LIVING WITH HISTORY

Certificate of Appropriateness

Property	2565 – 2567 N. TERRACE AV. North Point North HD
Description of work	<p>Exterior rehabilitation including:</p> <ol style="list-style-type: none"> 1. The creation of four corner pilasters on the first level to match existing flutes of first floor pilasters and to match the caps of existing second level pilasters; 2. The reproduction of corner moldings at existing vertical corners, reproduced to match existing and installed where needed; 3. Plaques mounted above corbels, reproduced in pine and matched to existing forms. 4. Water table restored to match existing where needed; 5. Eave horizontal bottom surface restored where needed to matching existing; 6. A new pre-hung stained oak 4-panel front door with Emtek hardware; 7. Replace porch ceiling light with more stylistically sympathetic model by Kichler; 8. Replace modern mail slot with mailboxes made by Ecco; 9. Replace front decking with t&g boards running perpendicular to the house; 10. Finial replacement, round design more stylistically sympathetic/period appropriate; 11. Scraping, caulking, and painting the exterior, glazing windows where needed; 12. Replacement of two

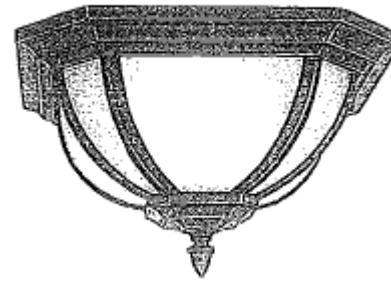
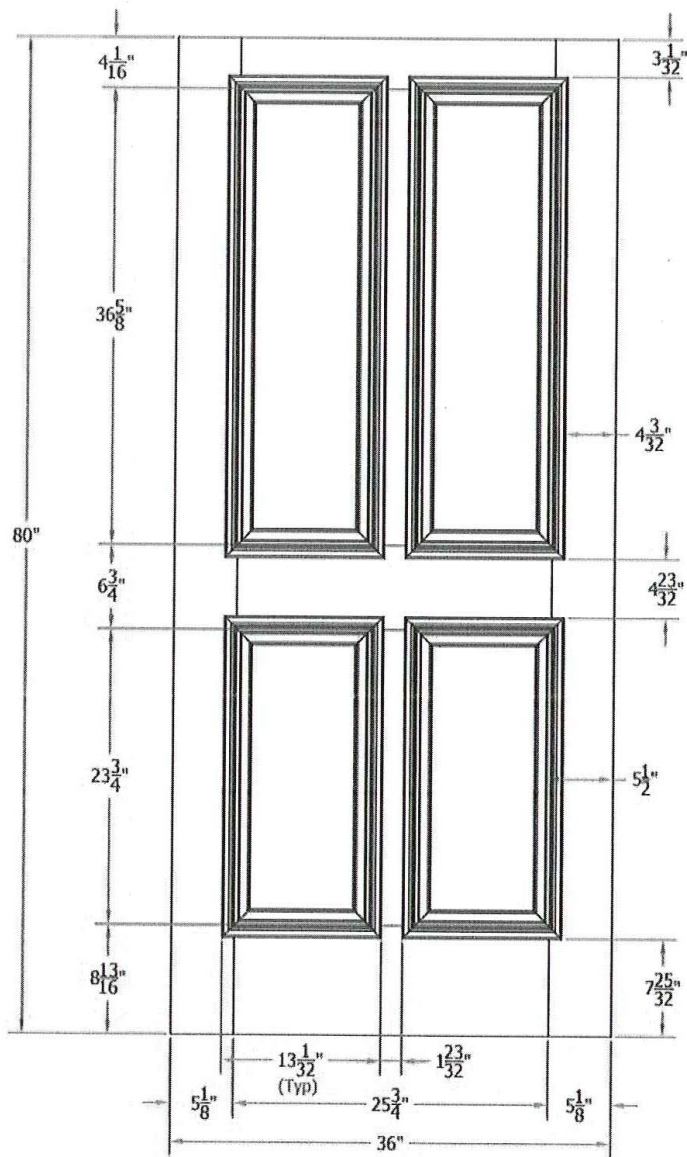
Corner pilasters (x 4) on first floor to match existing flutes on first floor pilasters with plinth and cap to match existing two story pilasters and second story pilasters.

Convex and concave corner moldings at existing vertical corners to be reproduced to match existing and installed where needed.

Plaques mounted above corbels to both be reproduced in pine to match existing in form and dimension and installed where needed along with connecting molding.

DRAWING NO. D-3044-300-608-0300

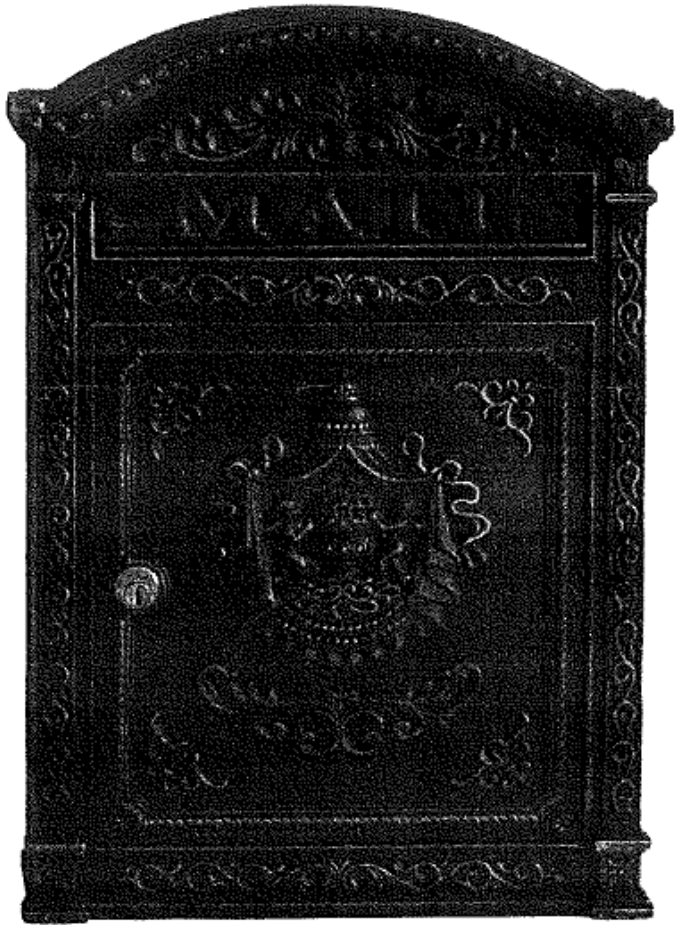
New pre-hung stained oak 4-panel front door with Emtex hardware band handle. (see renderings).

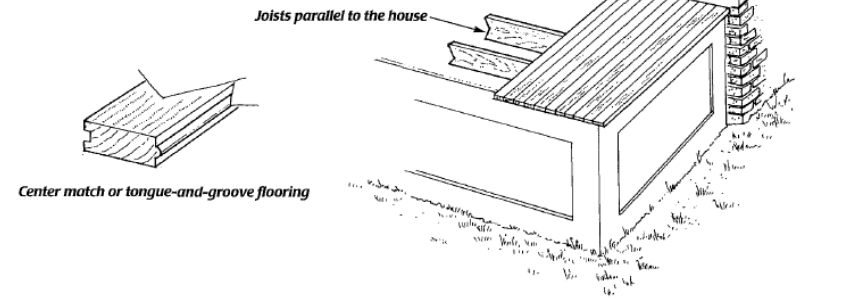
Front deck boards to be replaced with t&g boards that run perpendicular to the house. The front step boards to run parallel to the house.

Squared off ball finials on deck newels to be replaced with round ball finials mounted on reproduced newel caps that are more period appropriate and match existing profiles on the house.

The members to which the flooring is attached, should always be run parallel to the house so that the floor boards can be installed perpendicular to the house. The porch floor should also be very slightly pitched away from the house. This method of construction for a porch floor will shed water and make the porch last longer.
